## **ADDENDUM NO. 1**

Driveway Entrance Removal and Driveway Entrance Modifications  
to Aldi at 561 Gateway Avenue

For  
The Borough of Chambersburg, PA

PLAN NO.  
E-411

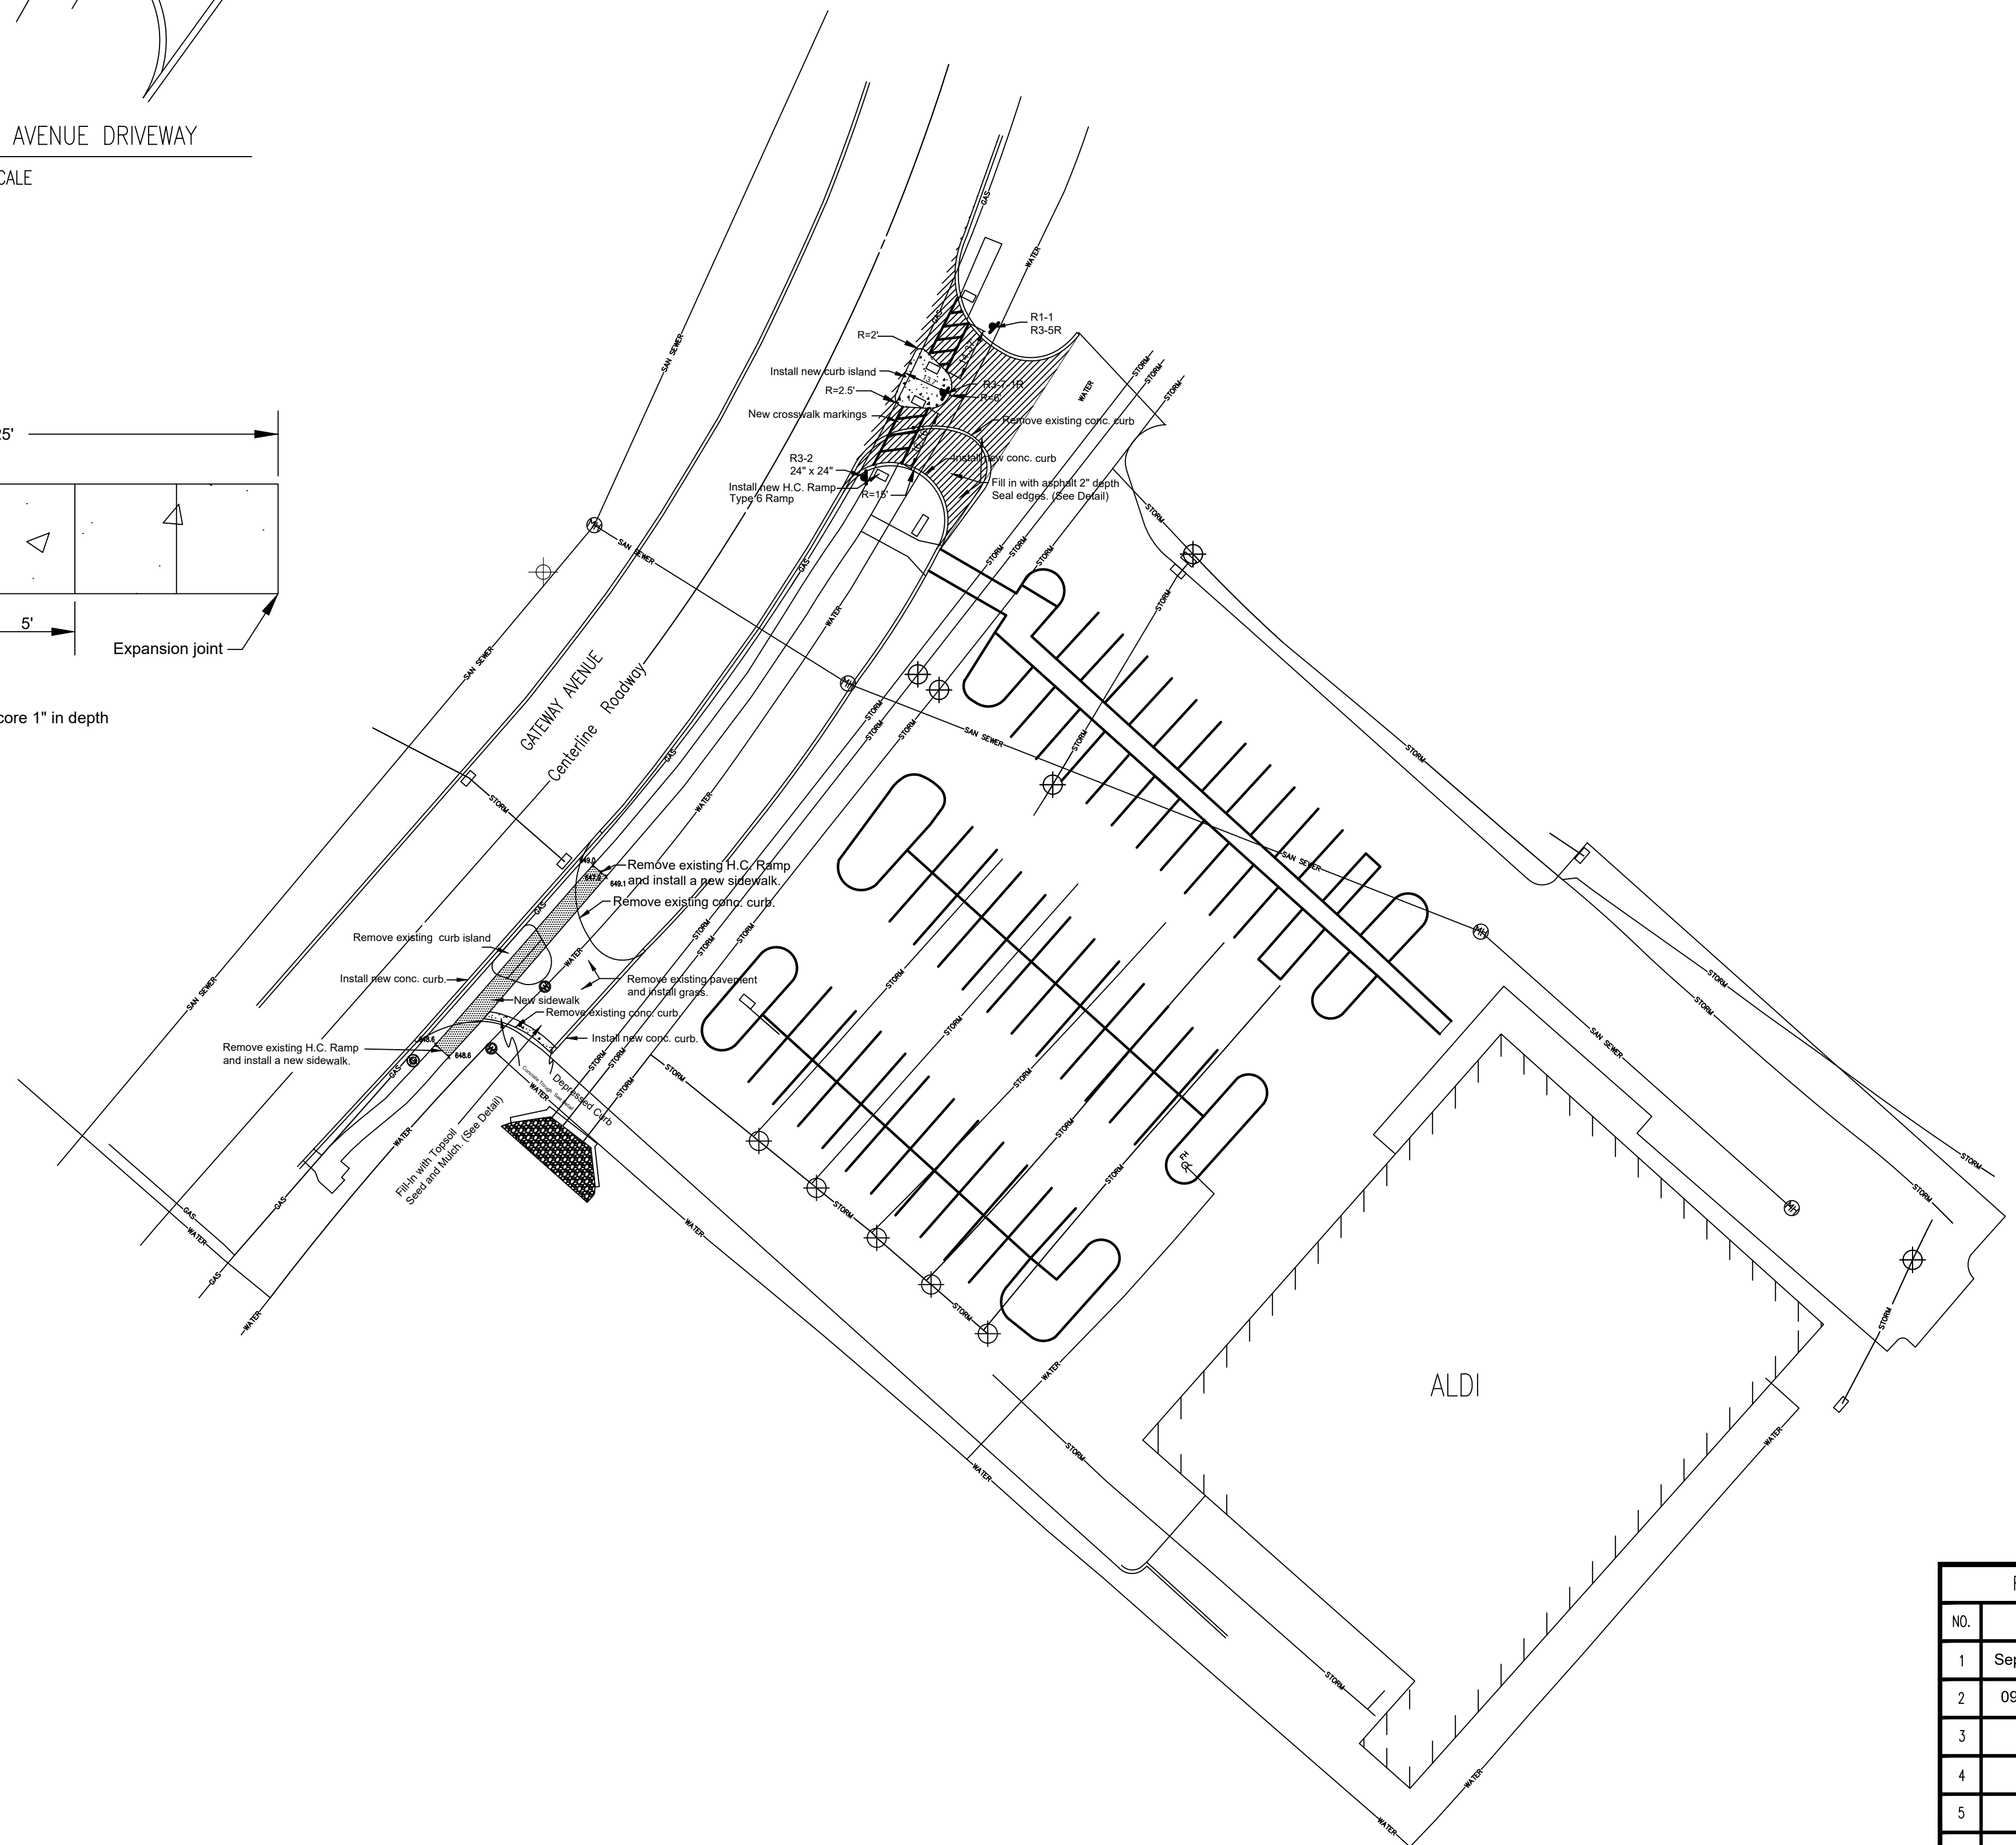
- Plans/specifications have been revised to extend bid due date to 10 am on October 7, 2022.
- Plans/specifications have been revised to modify the contract timeframe in Specifications, Item 1 to “...between October 24, 2022 and November 23, 2022...”.
- Plans/specifications have been revised to provide details for curb island.
- Plans/specifications have been revised to show area of new asphalt pavement.
- Plans/specifications have been revised to show areas requiring topsoil, seed, and mulch.
- Plans/specifications have been revised to show additional North Entrance dimensions.
- Plans/specifications have been revised to show curb channel detail and location.
